Assessment Officer Report

(CA63) 9 Chamois Road and unleased
Crown land to the west, Mount Buller
PA2504101

Officer Assessment Report Development Assessment

Figure 14 – Location of Tree No. 4 (highlighted in yellow) – (Source: Application (modified by DTP))

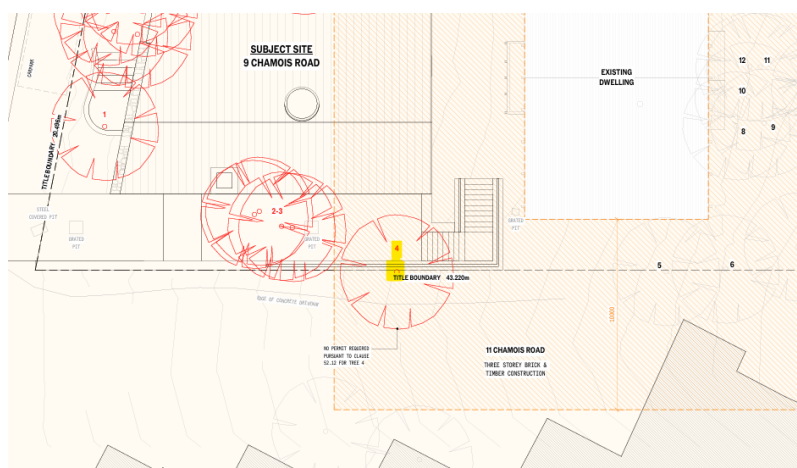
76. One objector raised concerns regarding the removal of Tree No. 4, stating that this tree is located on their land and consent regarding its removal without consent. (Refer to Figure 14).

77. The tree appears to be located on the mutual boundary with the objector property, however this tree is exempt from requiring a permit pursuant to Clause 52.12-1 of the Scheme. Tree No. 4 is located within 10 m of an existing building used for accommodation that was constructed before 10 September 2009. As such, assessment of this tree

is not a matter for consideration. Nonetheless, the applicant submits that the leaseholder will work cooperatively with the leaseholder of the objector property in relation to the trees removal.

Figure 15 – 'Without prejudice plan', showing section of eastern side retaining wall – (Source: Applicant submitted on 30 March 2026)

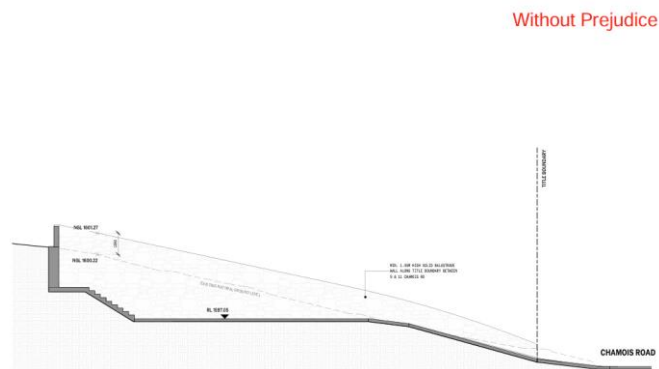
83. Concerns were raised by the objectors about potential impact to their newly constructed heater driveway that services all 5 objectors. They raised concerns that access could occur onto their site during construction without permission.
84. To address this issue, the applicant prepared a 'without prejudice' plan that shows the length of the retaining wall along the eastern lease boundary (mutual boundary) extending further south to the south/east lease corner and to include a 1 metre high balustrade. (Refer to Figure 15). DTP circulated the plan informally to the objectors however no further responses were received from any submitters.

85. Nonetheless, it is considered appropriate to include a condition to require the architectural plans to be modified and to include the retaining wall along the eastern side to be increased in length and to include a 1 m high balustrade along its length (similar to the submitted 'without prejudice' plan). The lengthening of the retaining wall will form a

tangible boundary between the development site and the neighbouring site and will ensure that the recently constructed heated driveway that services the 5 objectors will not be impacted. Furthermore, accessing a neighbouring property is prohibited unless the permission has been obtained by the leaseholder of that site, so there should not be any impact or access into the neighbouring property during construction.
